**Project #20-031
1700 North Retail Development
Located at 1700 North Main Street**

Project Name: 1700 North Retail Development
Proponent / Owner: Justin Campbell / CH Champlin
Project Address: 1700 North Main Street
Request: Design Review Permit
Current Zoning: Commercial (COM)
Type of Action: Quasi-Judicial
Hearing Date: June 25, 2020
Submitted By: Russ Holley, Senior Planner

Staff recommends that the Planning Commission **conditionally approve** a Design Review Permit for Project #20-031, 1700 North Retail Development, for two (2) 11,520 SF commercial buildings located at approximately 1700 North Main Street, TIN #04-082-0013, 04-177-0003; - 0002.

ARCHITECTURAL
ELEVATIONS

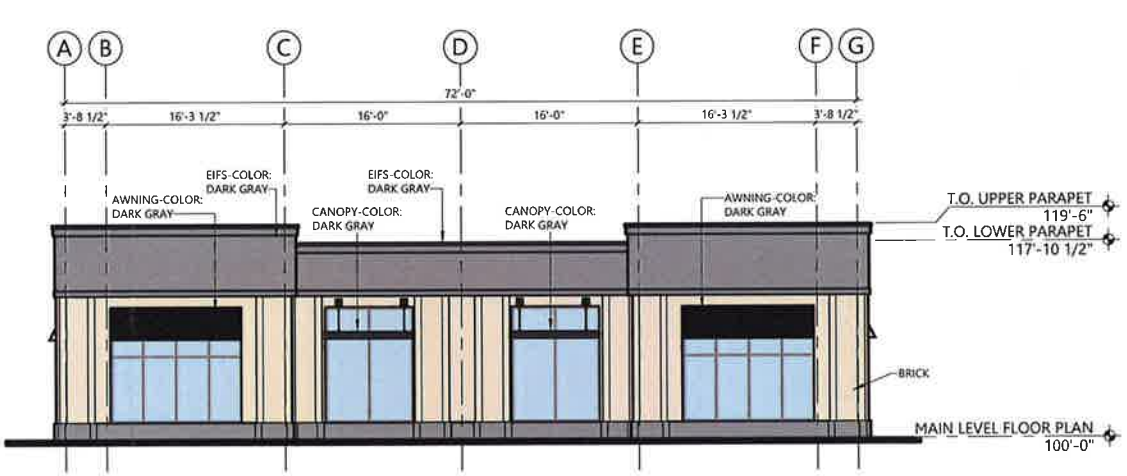
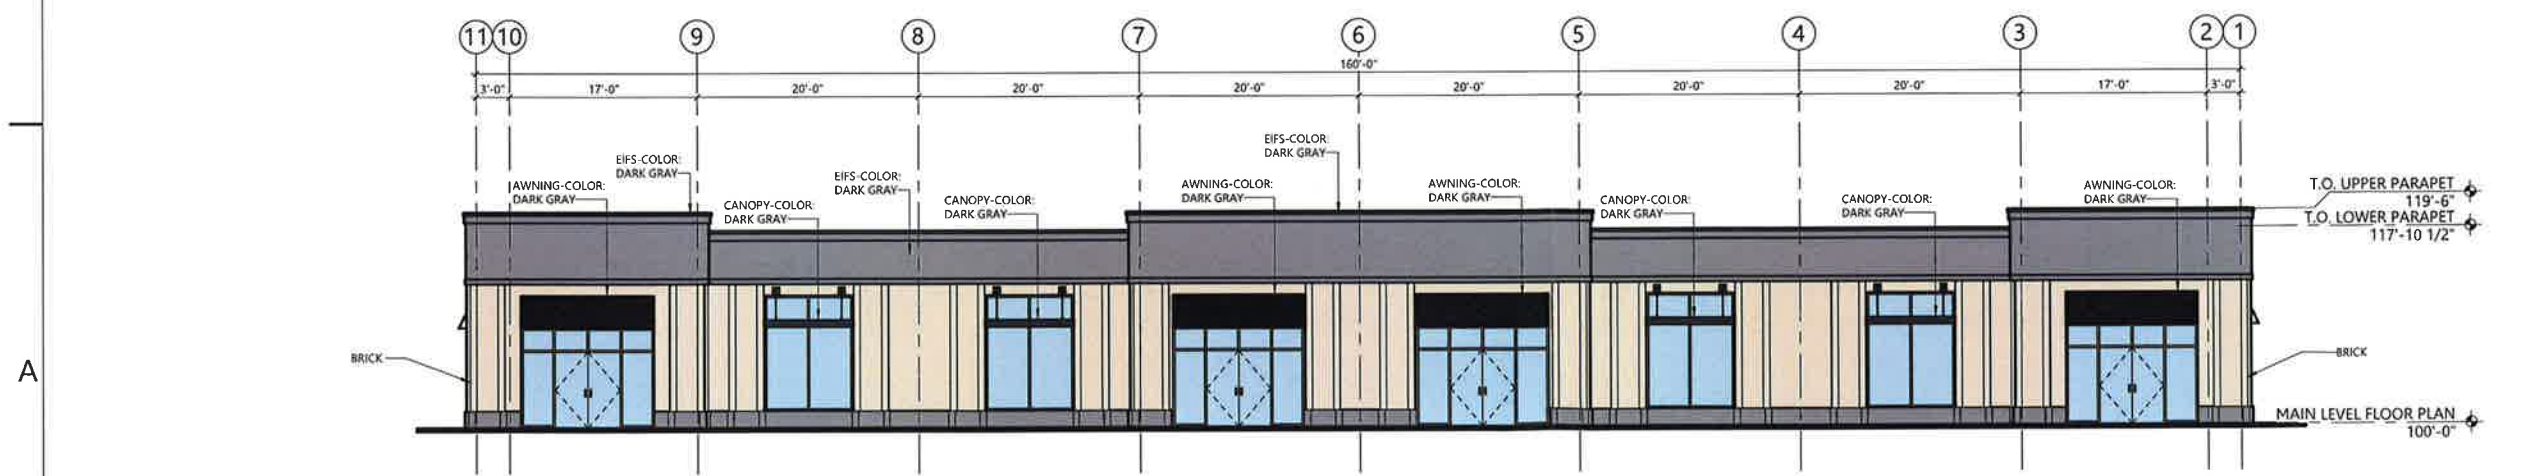
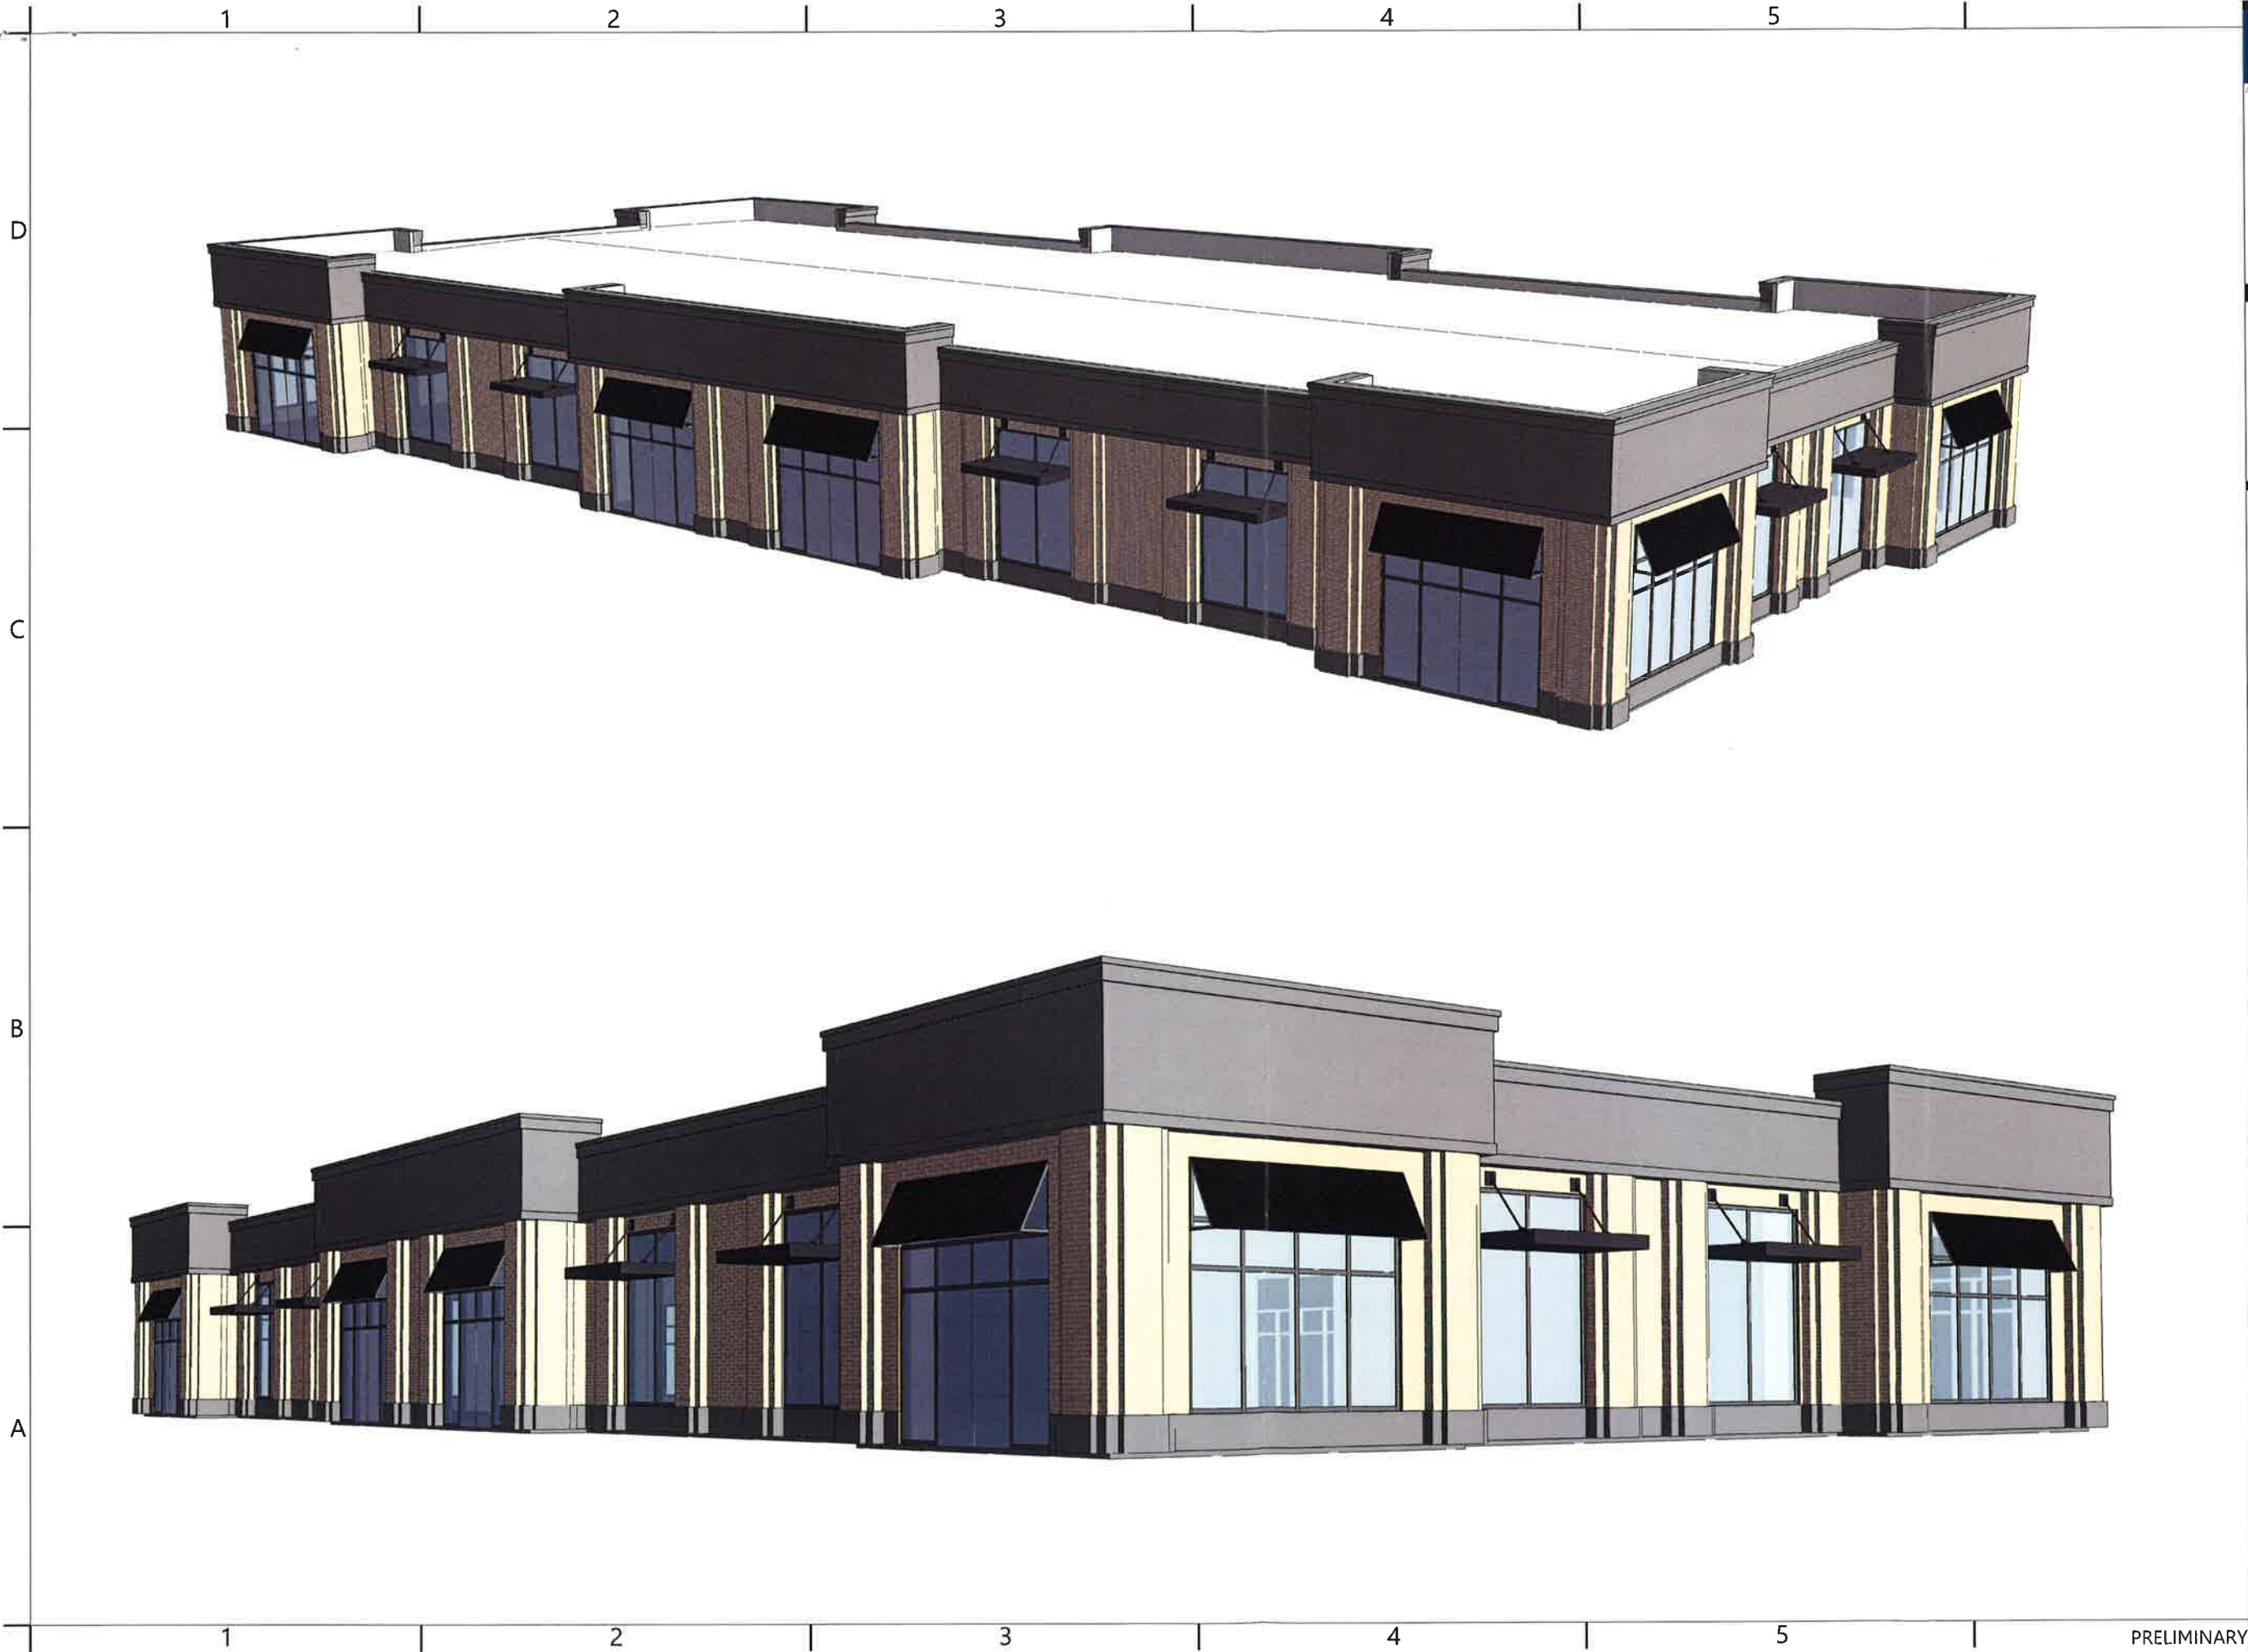
The LDC 17.12.020 states that commercial buildings should be designed to promote high-quality and aesthetically pleasing developments. The design standards consider building variation, materials, building mass, articulation, roof, placement, and orientation. The standards emphasize 4-sided architecture and street orientation. The proposed brick buildings meet the design standards. The buildings have clear horizontal and vertical articulation, and massing with a mix of brick, EFIS and glass storefront materials. For design variation, no two directly adjacent commercial building should possess the same front façade. The two proposed commercial buildings along Main Street are identical and do not meet building variation standards as proposed. The LDC requires certain criteria to be considered varied from adjacent buildings. To meet the code, the commercial buildings are required to differ by at least 3 of the 7 criteria listed in LDC 17.12.020. As conditioned with building variations, the project complies with the requirements in the LDC.

With the exception of the façade variation requirements for directly adjacent building in the LDC, the proposed project complies with code requirements. The variation requirements in the code intend to avoid the appearance of “cookie cutter” projects and neighborhoods that lack visual interest and variety. The Planning Commission will need to determine if any design discretion as per 17.43.080 is warranted in this case of two identical buildings.

2. No two adjacent buildings may possess the same front/street-facing elevation as per façade variation standards in LDC 17.12.020.C.
3. A minimum of 92 parking stalls and a bike rack shall be provided for Phase-1. Parking requirements will be reviewed and approved for each subsequent business license application within Phase-1.

PROJECT
CONCEPTUAL SITE PLAN
CHAMPLIN DEVELOPMENT
1600 NORTH MAIN STREET
LOGAN, UT 84341

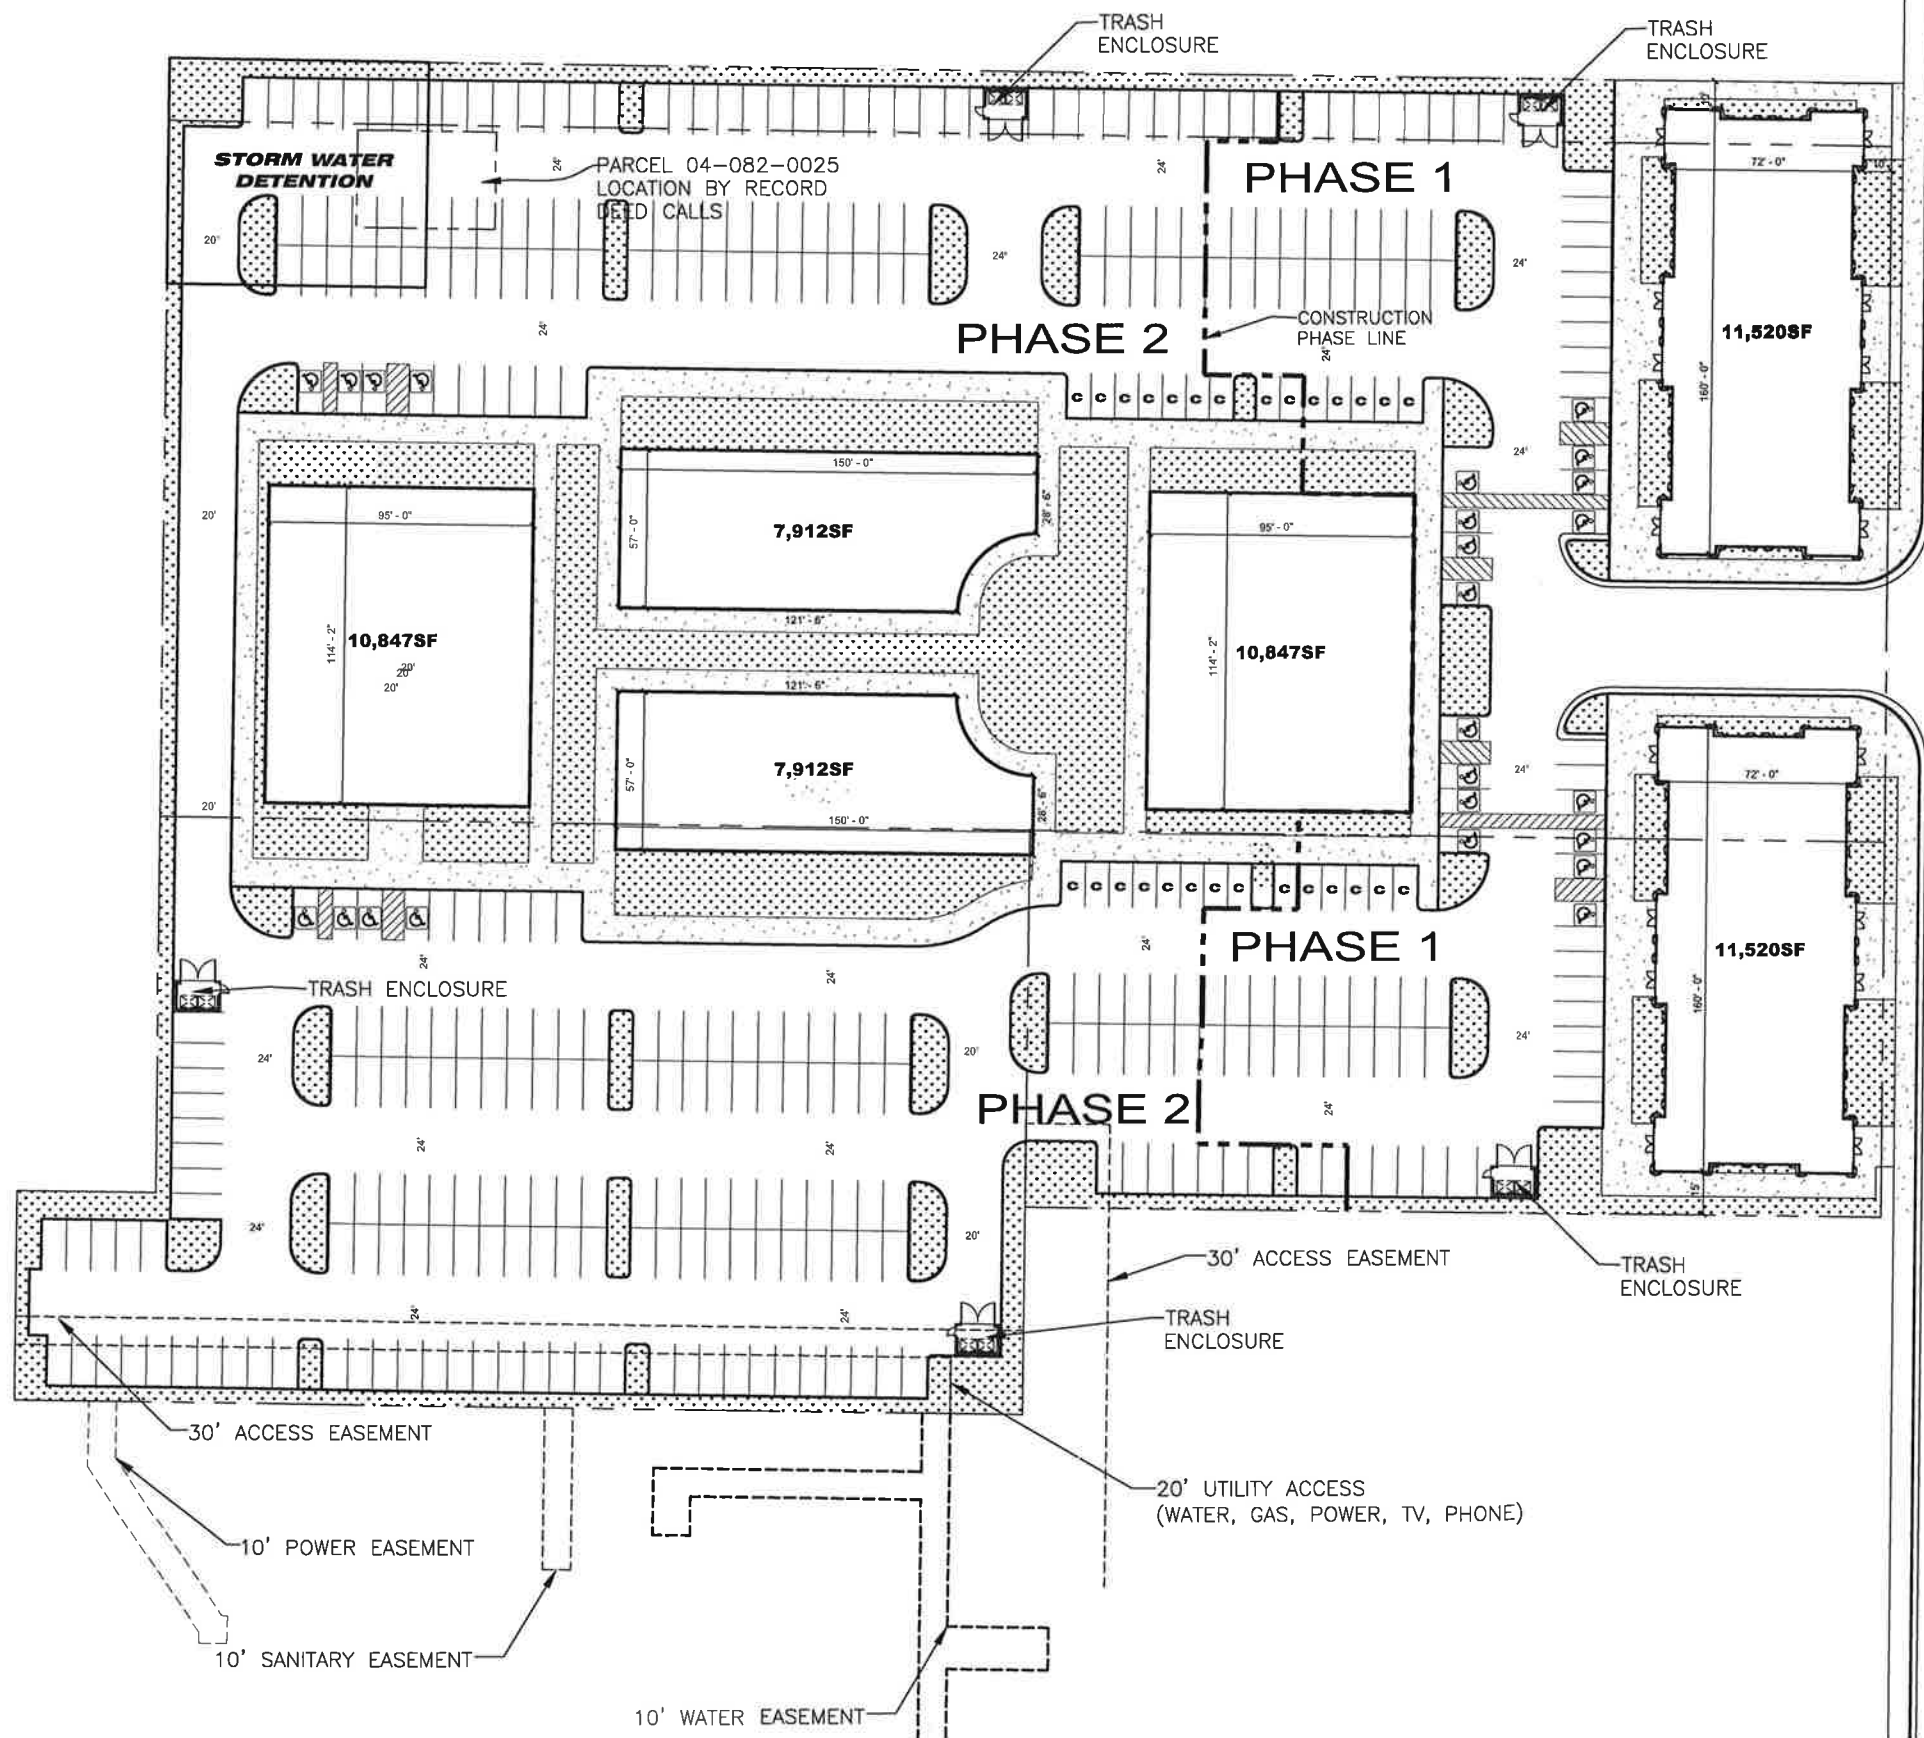
- Plan shows parking and access to be placed on pump house and well owned and operated by North Logan. Unless North Logan is relocating this well this will not be allowed.

- Fire Hydrants will be required within 400 ft of all points around the exterior of all buildings and within 100 ft of any fire department connections (FDC). Applicant shall provide an AutoCad drawing of the site with the maneuvering specifications of the largest fire apparatus; Inside Turn: 17 ft, Curb to Curb 32 ft, Wall to Wall 36 ft
